FINAL DRAFT MINUTES

September 20, 2012 Standards Committee Meeting

RE: Minutes from the September 20, 2012 Standards Committee Meeting

REVISED STANDARD DRAWING 805-SGSP-04 BASE PLATE FOR SIGNAL STEEL STRAIN POLE (DRAFT)

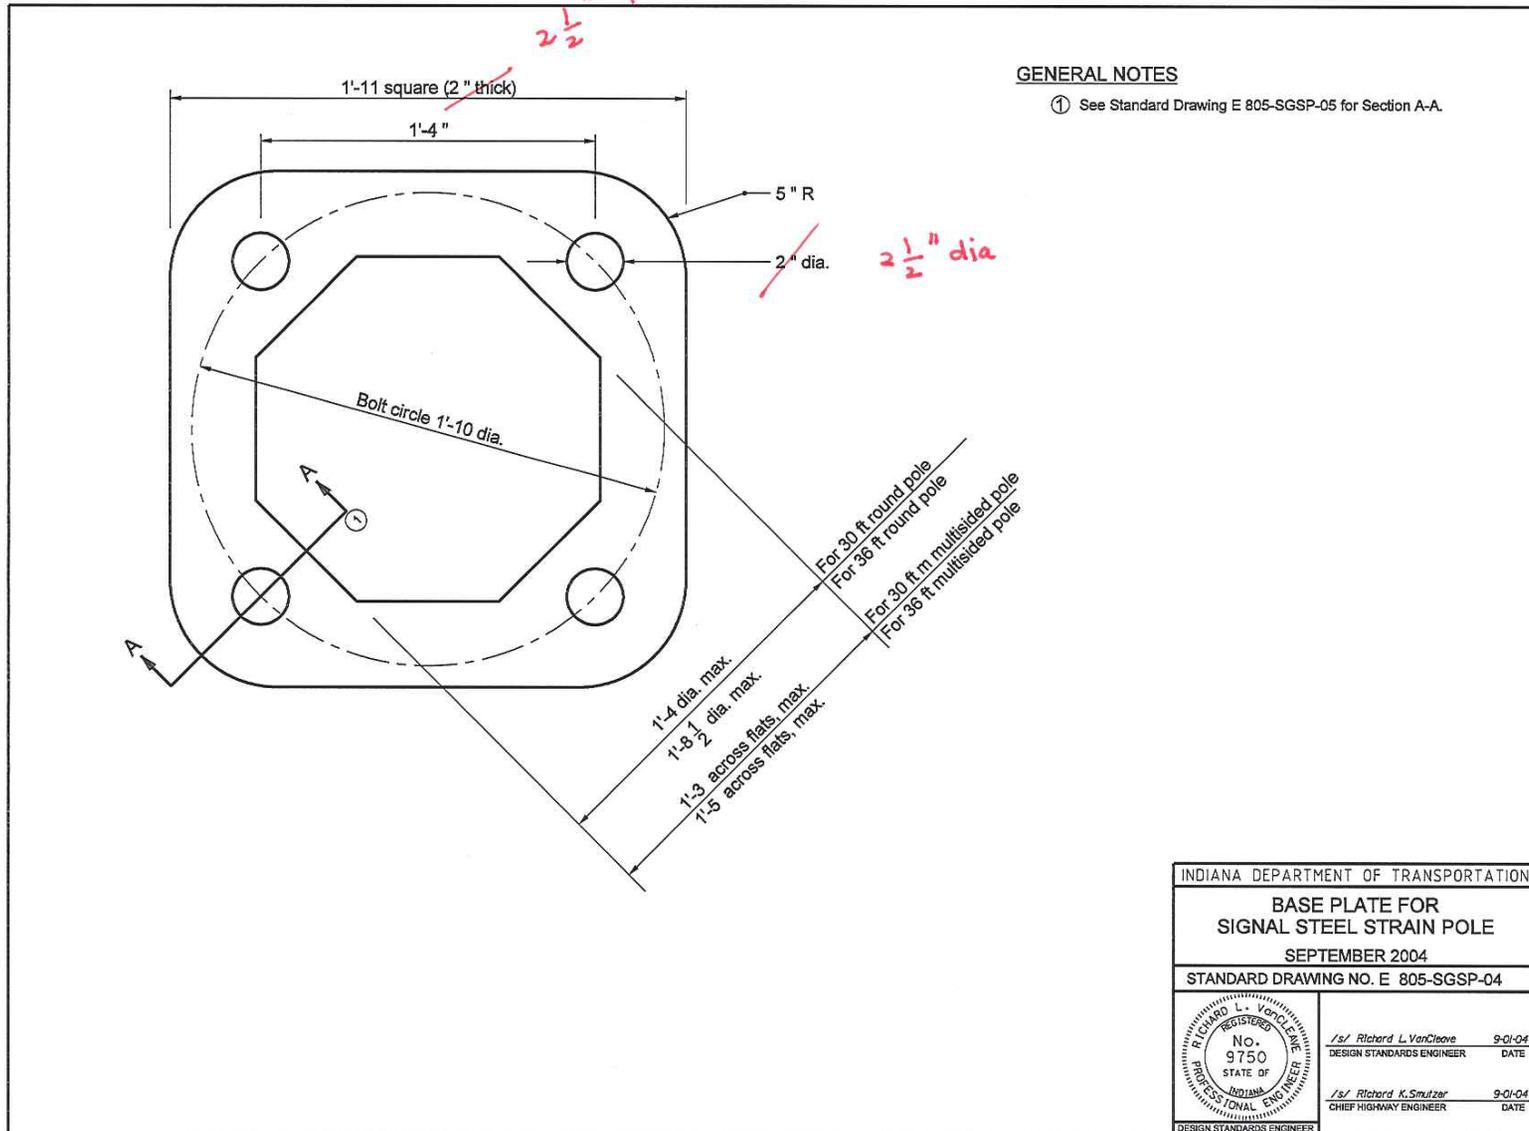
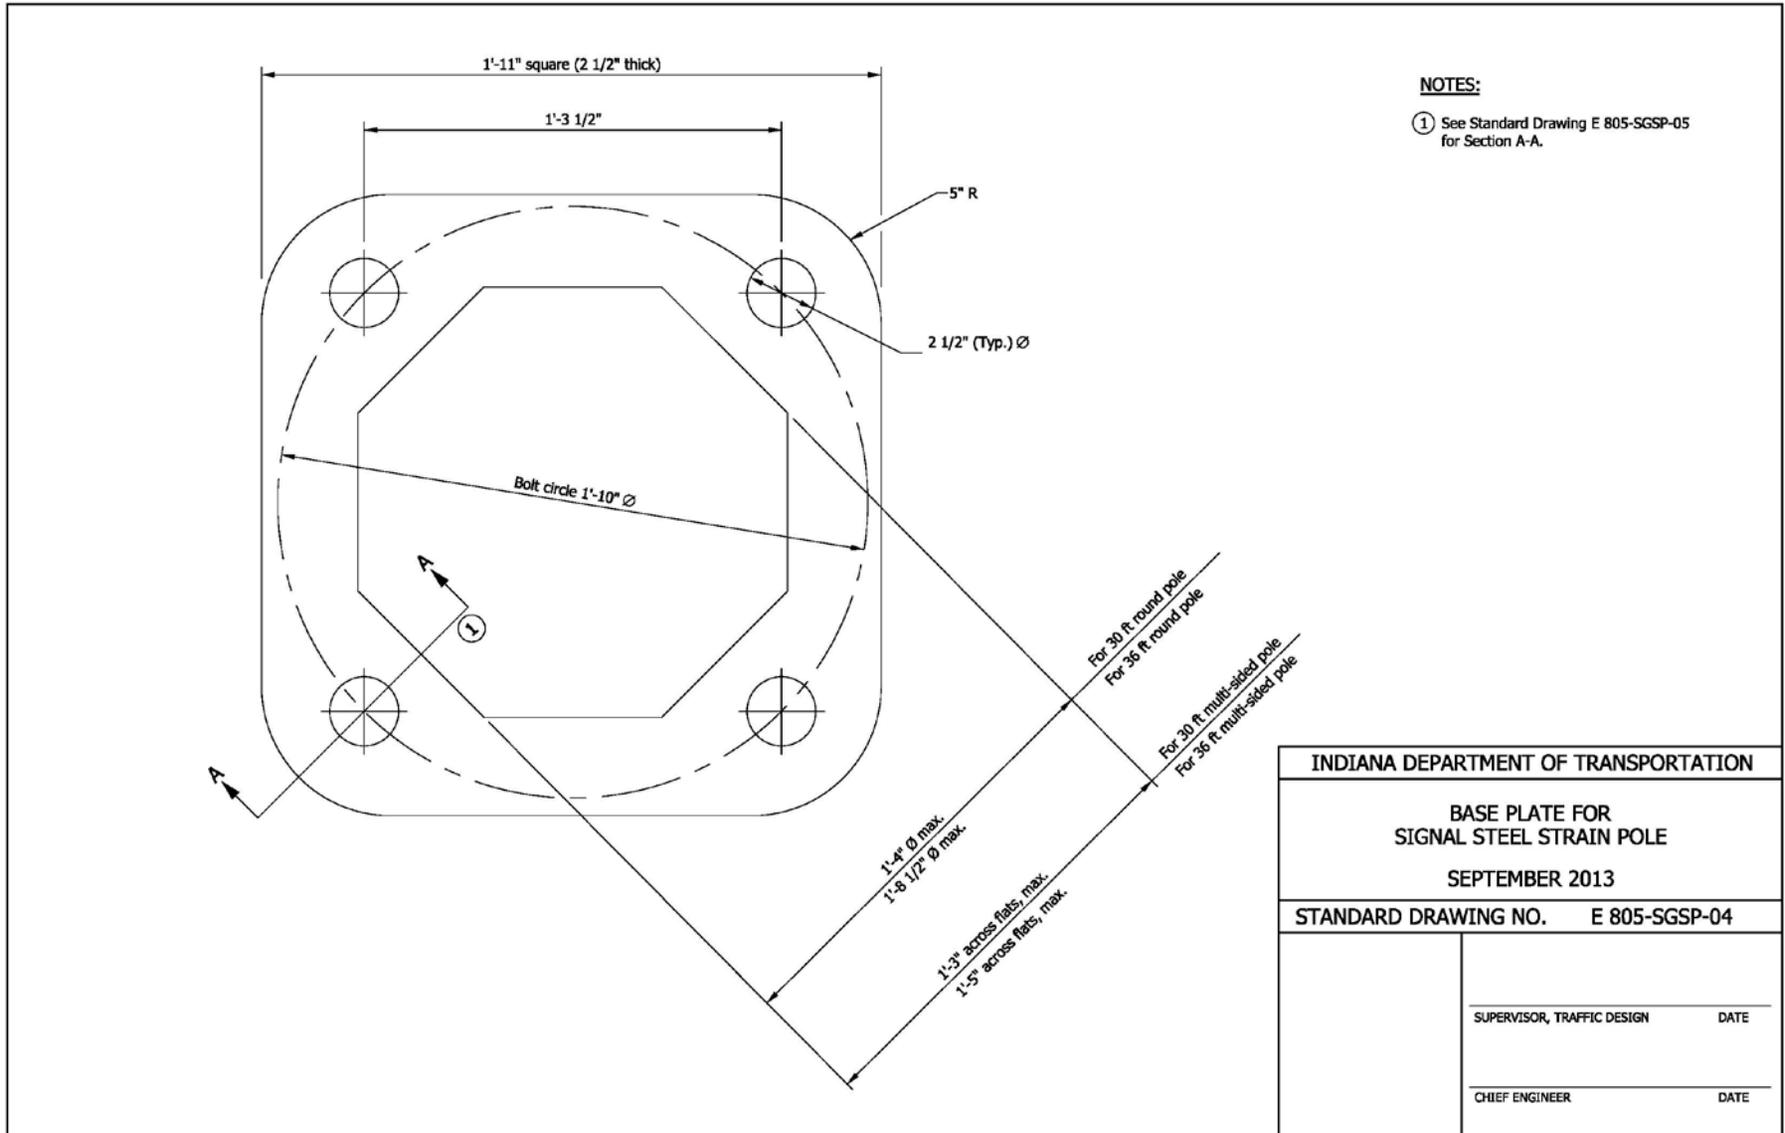
1. On panel sign assemblies the distance between the bottom of the panel sign and the top of the fuse plate often varies from one post to the other in the same assembly. This may lead to the breakaway mechanism not functioning correctly.
2. Clips that attach the sign panel to the support I-beams are not being installed on both sides of the I-beam for signs wider than 24' as they should be. This makes it more likely that the sign will separate from the supports.
3. Standard Drawing 805-SGSP-04 for signal strain poles contains incorrect dimensions for the base plate thickness and anchor bolt hole diameter.

Mr. Boruff continued explaining the rest of the revisions presented. Ms. Phillips asked about the bolt circle and Mr. Boruff stated that it is correct and that it is centered.

1. Add a note to Standard drawing 802-SNGP-01 that "The distance from top of the fuse plate to the bottom of the sign shall be the same for all posts"
2. Revise Standard drawing 802-SNGP-03 to indicate that clips on both the left side and right side of the posts are required for signs wider than 24'.
3. Revise Standard drawing 805-SGSP-04 by correcting the anchor bolt hole diameter to 2 1/2" (currently shown as 2") and the base plate thickness to 2 1/2" (also currently shown as 2").

EXISTING 706-TTFC-01 CONCRETE BRIDGE RAILING TRANSITION TFC PLAN AND ELEVATION (WITH MARKUPS)

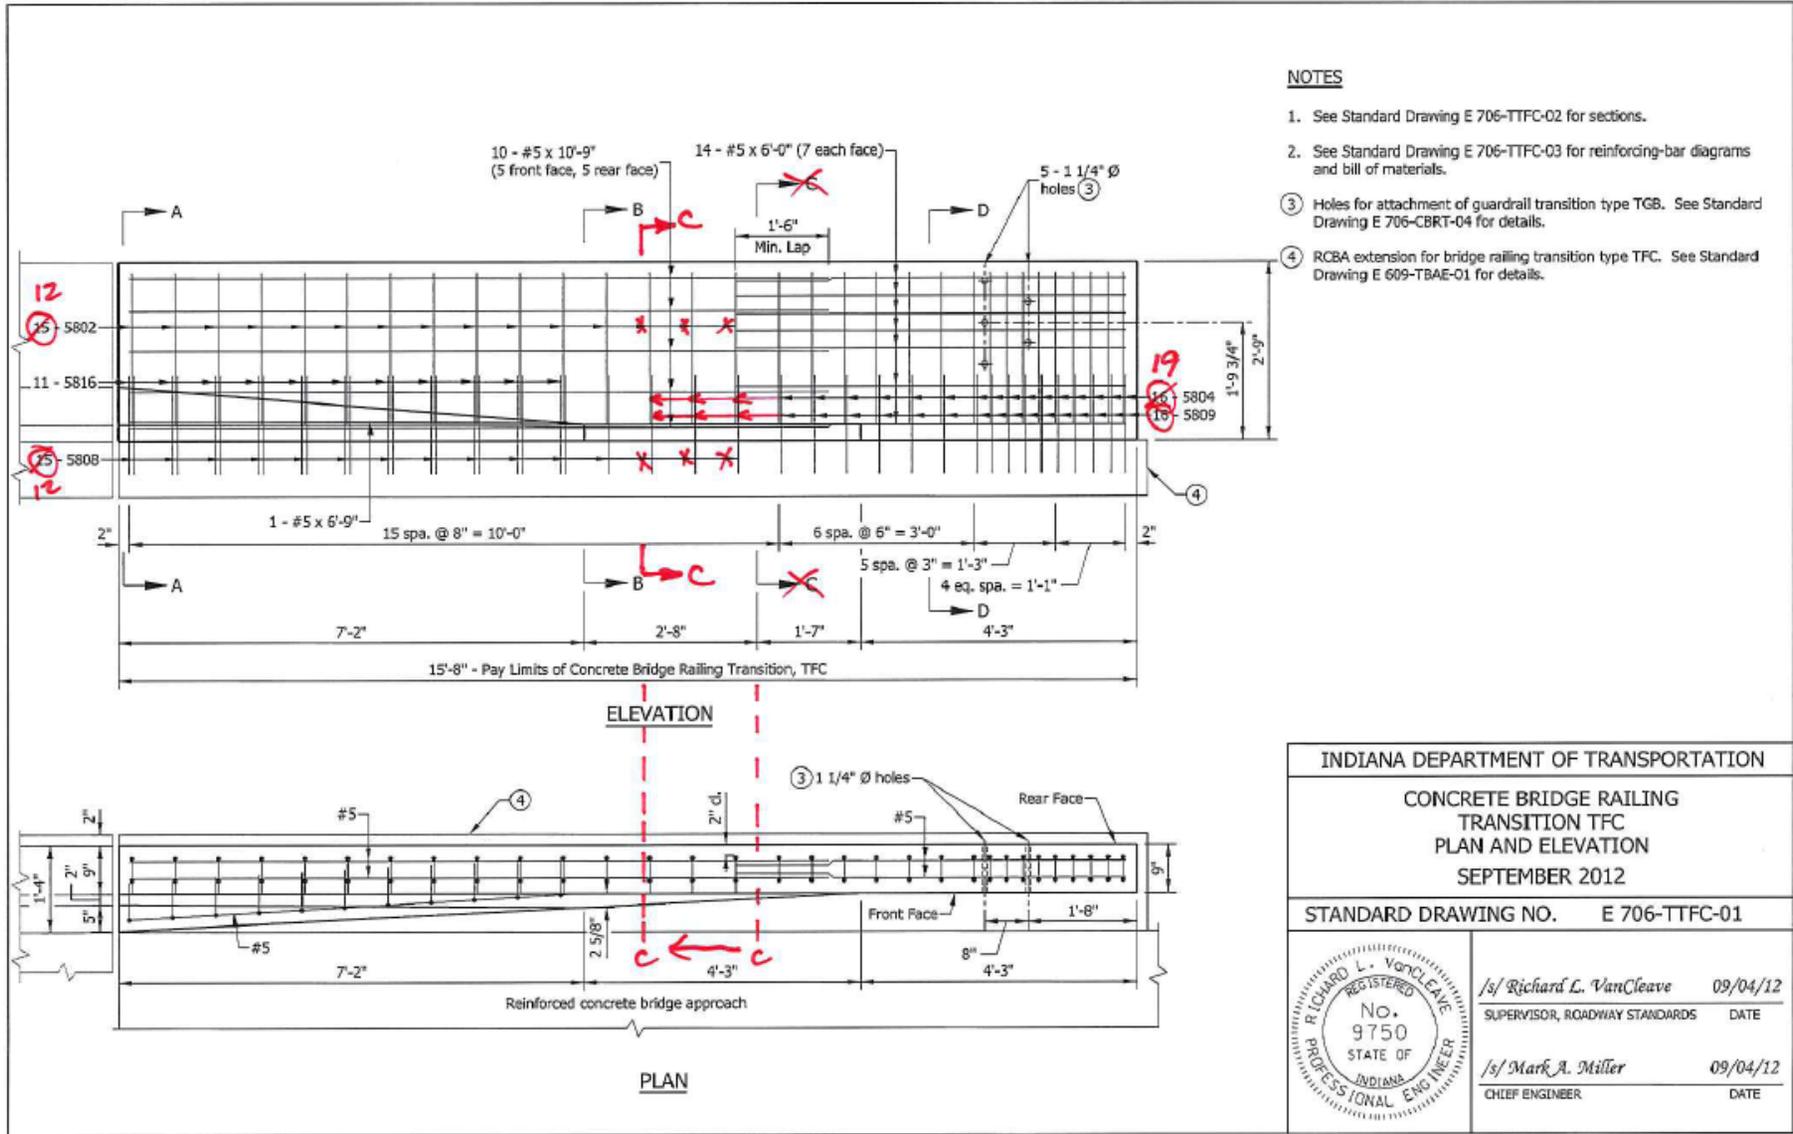
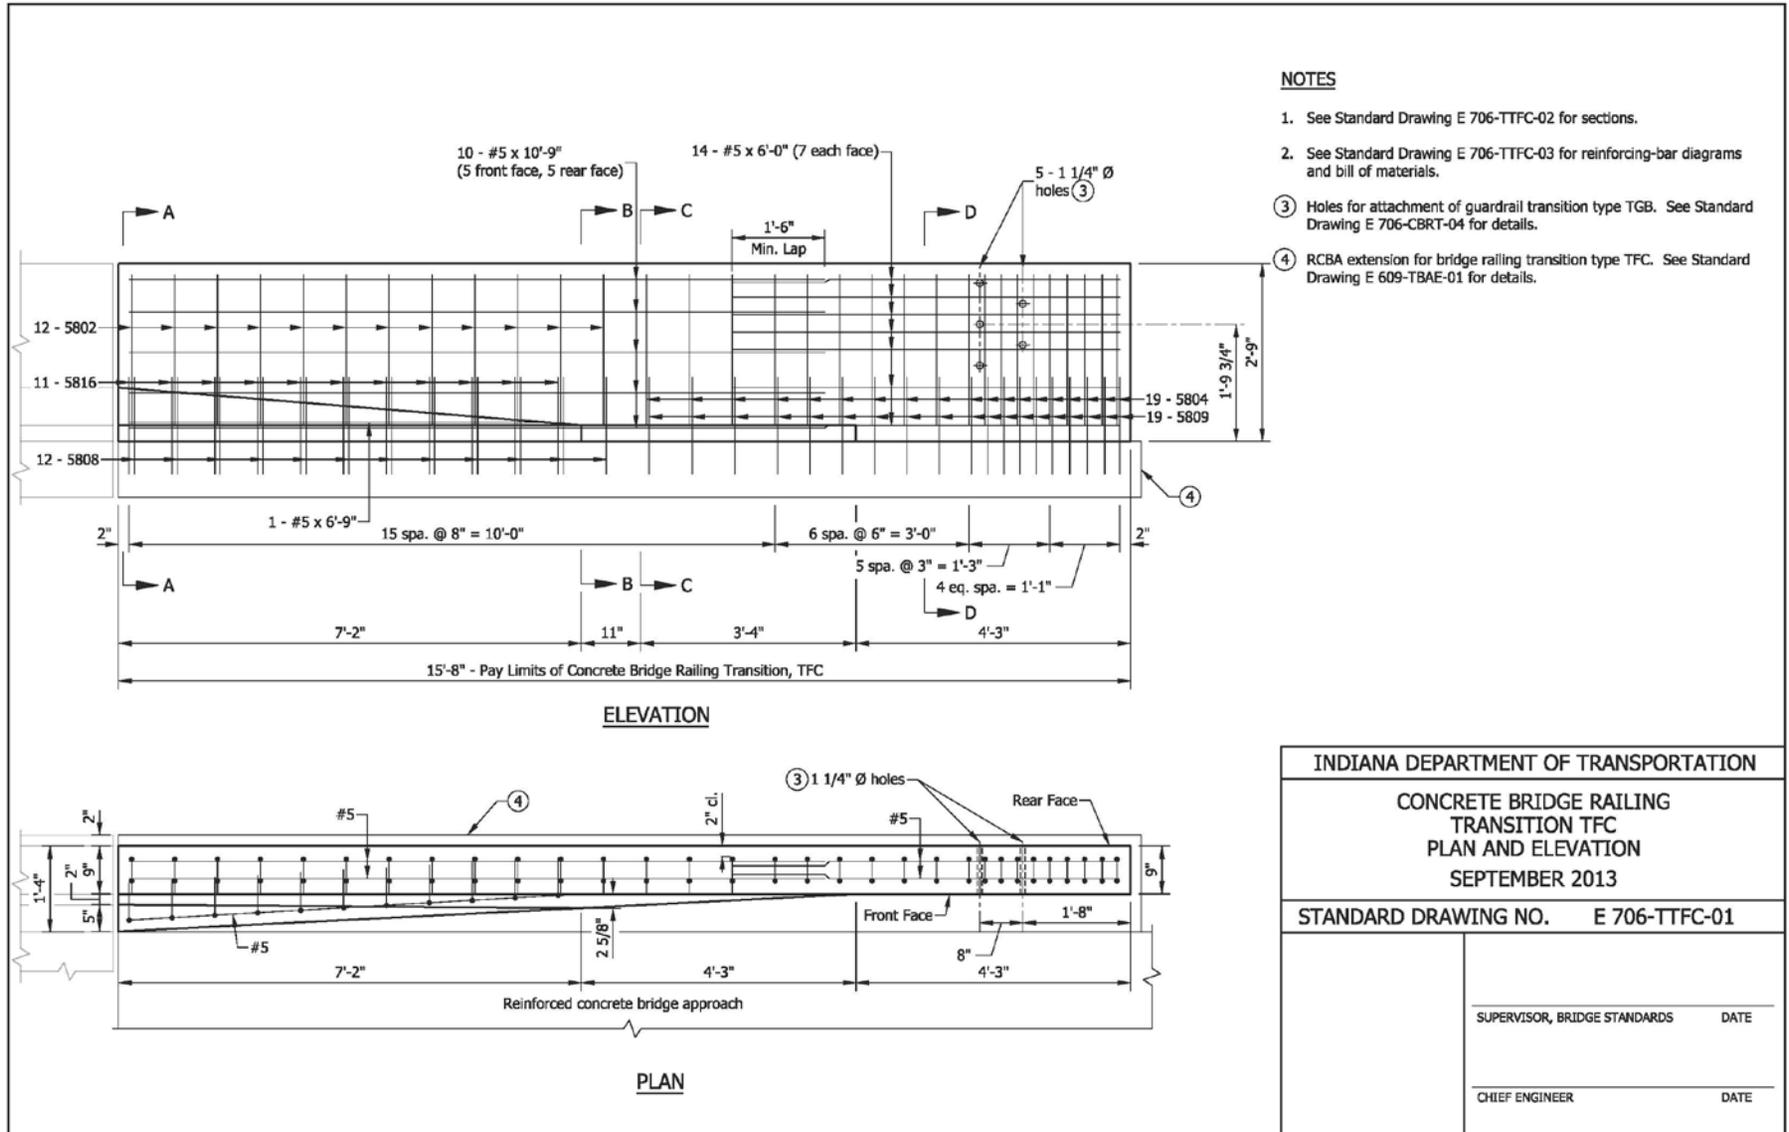
PROBLEM(S) ENCOUNTERED: A review of Standard Drawing 706-TTFC-01 through -03 revealed an error in the location of a section and consequently, an incorrect bill of materials.

PROPOSED SOLUTION: Revise the drawings to show the correct location of the section and quantities in the bill of materials. See attached markups and final drafts of proposed revised drawings.

706-TTFC-02 CONCRETE BRIDGE RAILING TRANSITION, TFC SECTIONS (DRAFT)

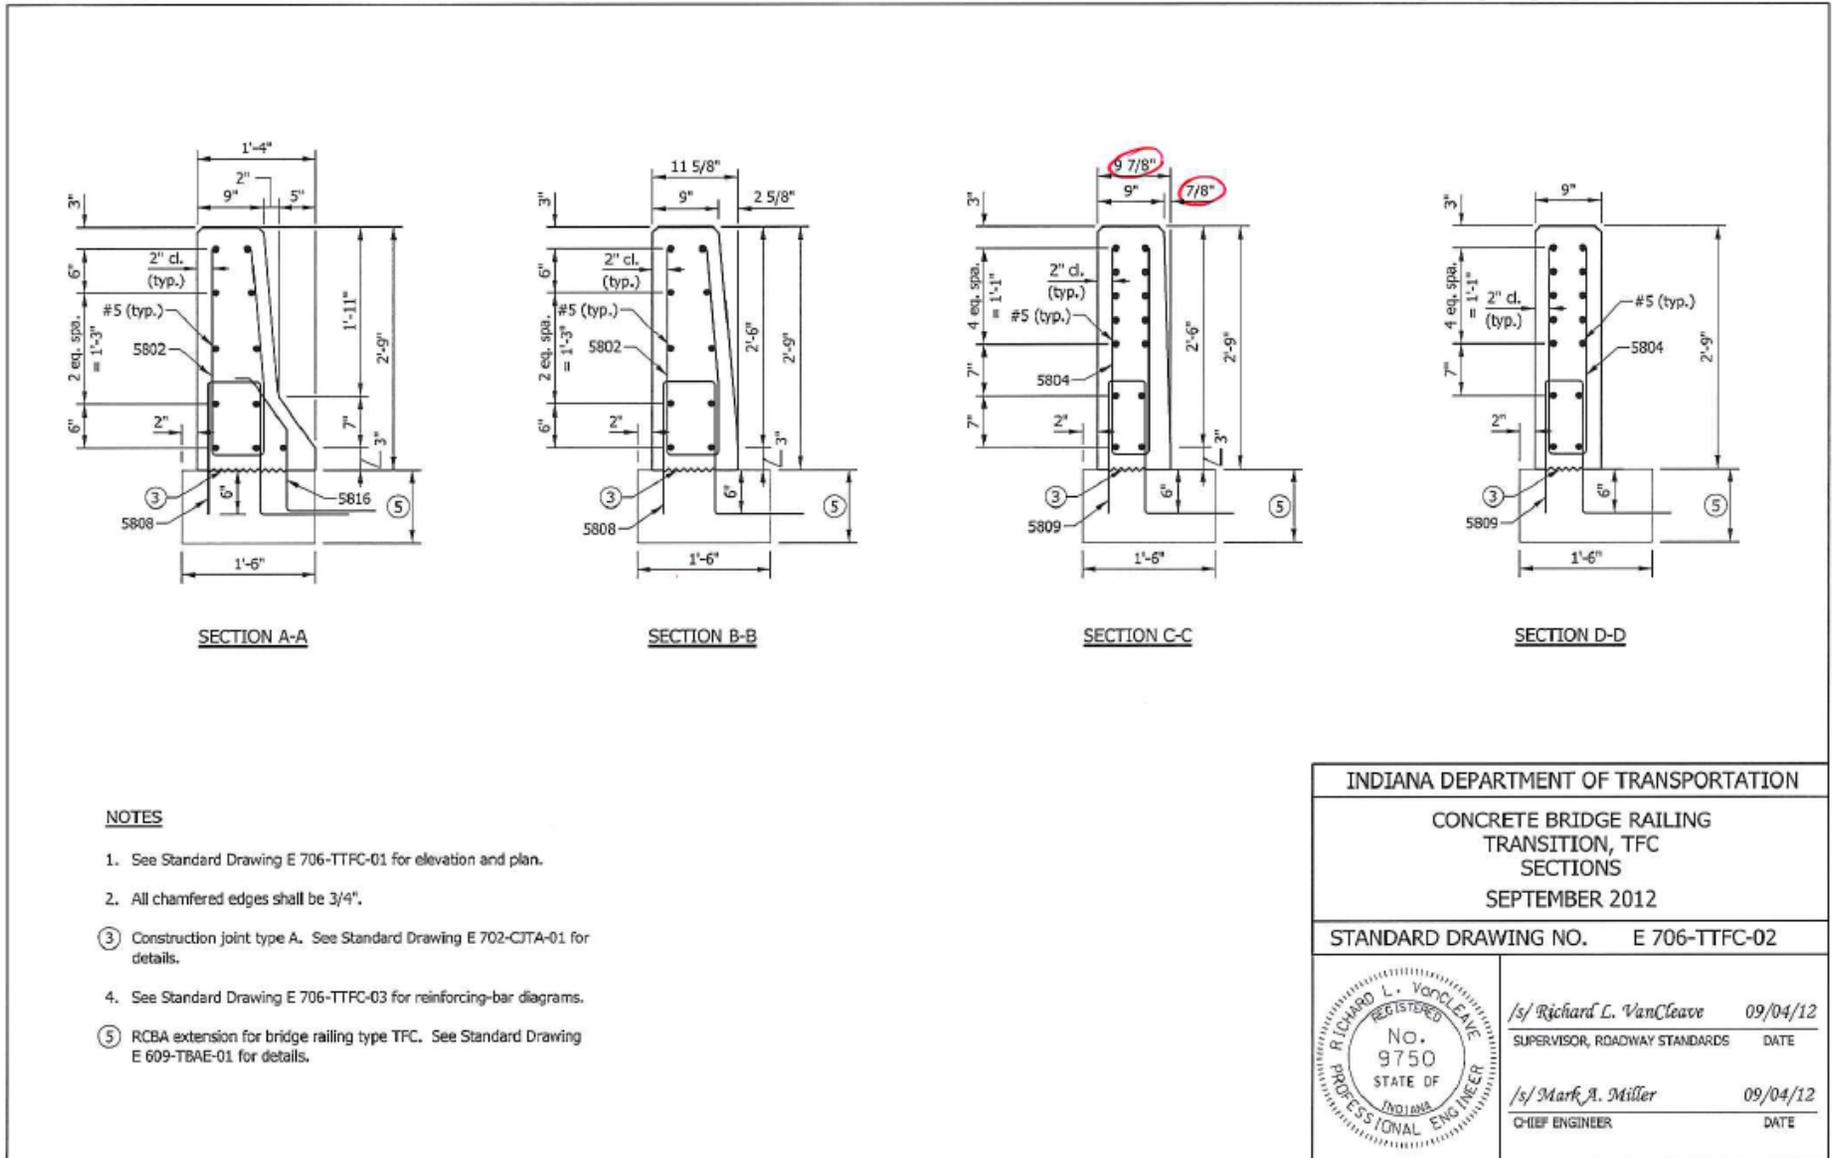
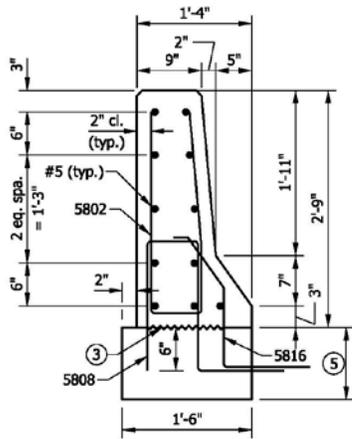
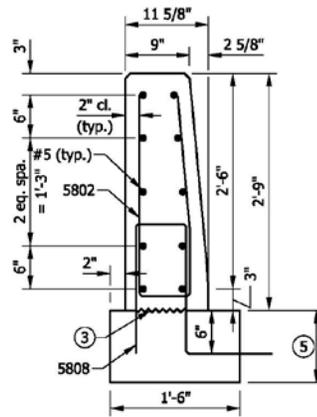
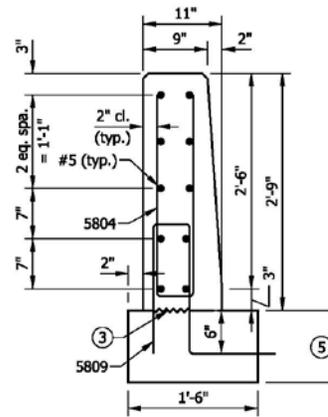
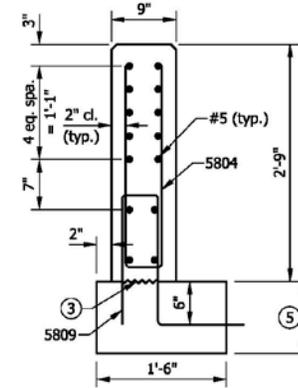
DISCUSSION: Ms. Phillips presented this item as shown and as described in the proposal page, and made a motion that this item be approved as submitted. Mr. Cales seconded that motion. Ms. Phillips then explained the revisions as shown attached above, and how the bill of materials is affected. A minor revision was recommended for section C-C, that the longitudinal bars should not be shown. Ms. Phillips will have that corrected.
